Product Change Notice (PCN)

PCN Number: PCN-0485189R-01

Product(s) Affected: *CPM1207 Series (CPM1207-02A-02-FRA-M9-67, CPM1207-03A-02-FRA-M9-67, CPM1207-04A-02-FRA-M9-67, CPM1207-05A-02-FRA-M9-67, CPM1207-05B-02-FRA-M9-67, CPM1207-08A-02-FRA-M9-67, CPM1207-12A-02-FRA-M9-67, CPM1207-17A-02-FRA-M9-67)*

Description of Change:

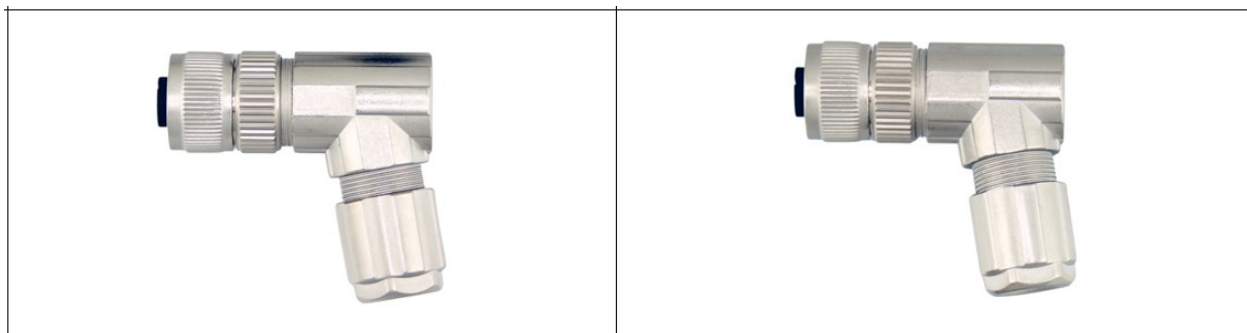
Material differences

- Female terminals have changed from brass to phosphor bronze

Mechanical differences

- Previous operating temperature -25, new operating temperature -40

Visual differences shown below
